Detailed Site Plan

9395 Lanham Dunkin

DSP-23034

SUBJECT: Detailed Site Plan DSP-23034
 9395 Lanham Dunkin

ELEVATIONS

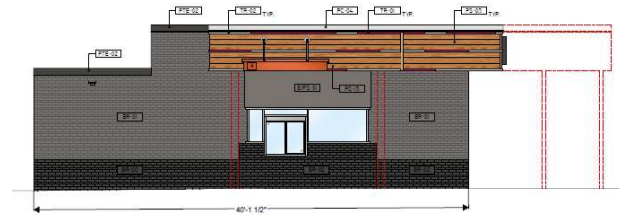
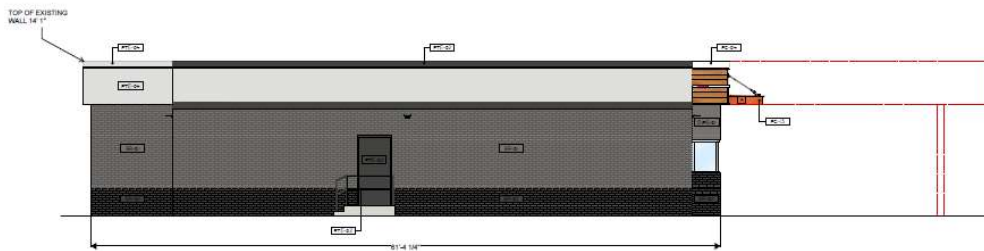
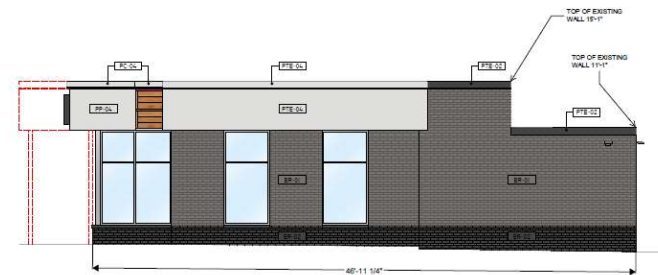
1. Drive aisle for one-way traffic should be at least 11-feet wide.
2. The front elevation on Sheet 5 and Sheet 7 are different regarding the proposed signage design.
3. Street connection width should be shown on the plans.
4. Height of existing building should be provided on site plan (Sheet 3).
5. The Permit Review Section offers no further comments at this time.

PHOTOMETRIC PLAN

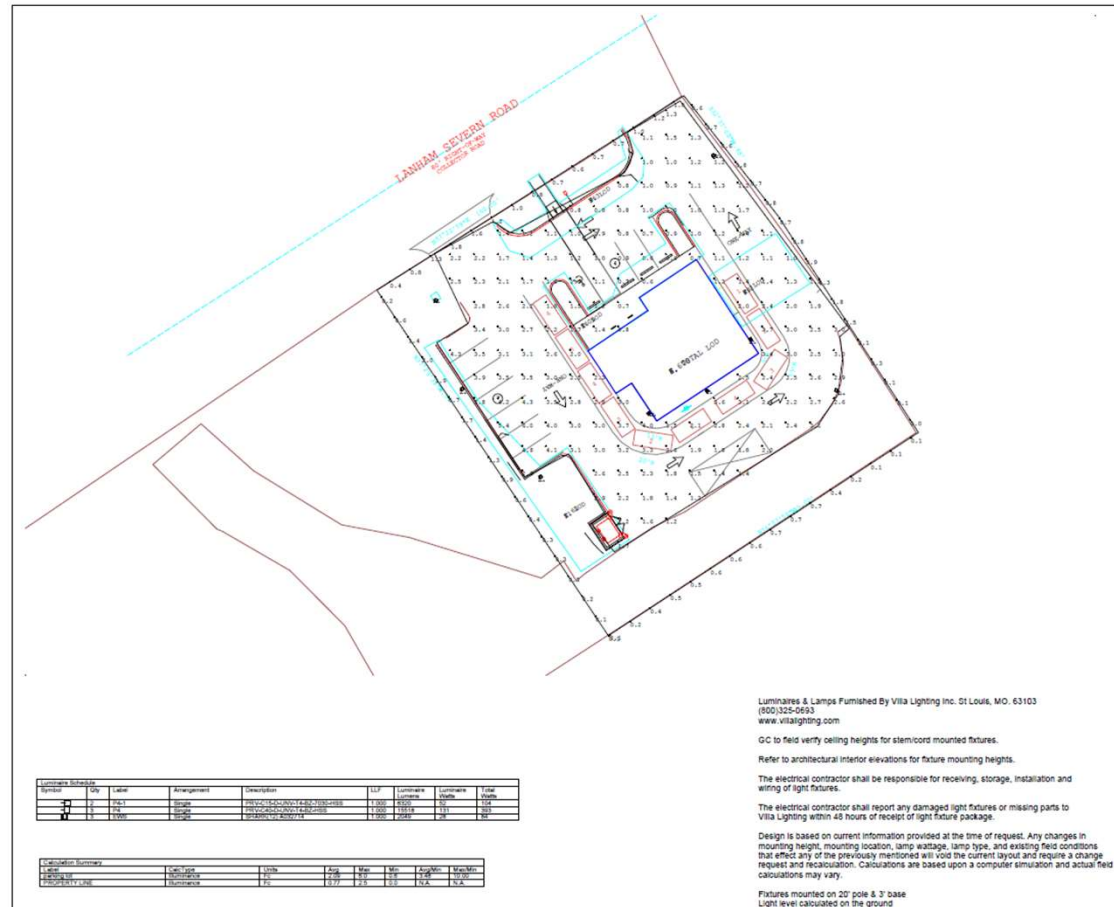
The photometric plan submitted with this application shows building-mounted and pole-mounted lighting on the site. Lighting will include existing wall pack and soft lights, which are to remain; new recessed-can downlights, within the proposed canopies and above the drive-through window; and pole-mounted lighting, to serve the western parking and entrance area.

Lighting for this DSP has been discussed in Finding 6 above, demonstrating an adequate variety of lighting fixtures to illuminate entrances, pedestrian pathways, drive aisles, and parking areas throughout. More importantly, the exterior light fixtures provide suitable quality of light, to enhance user safety and minimize any potential vehicular or pedestrian conflict in the evening. In addition, the light fixtures are durable and compatible with the scale, use, and architecture of the site. The pole-mounted lighting will be directed on-site to serve the southwest parking and entrance area.
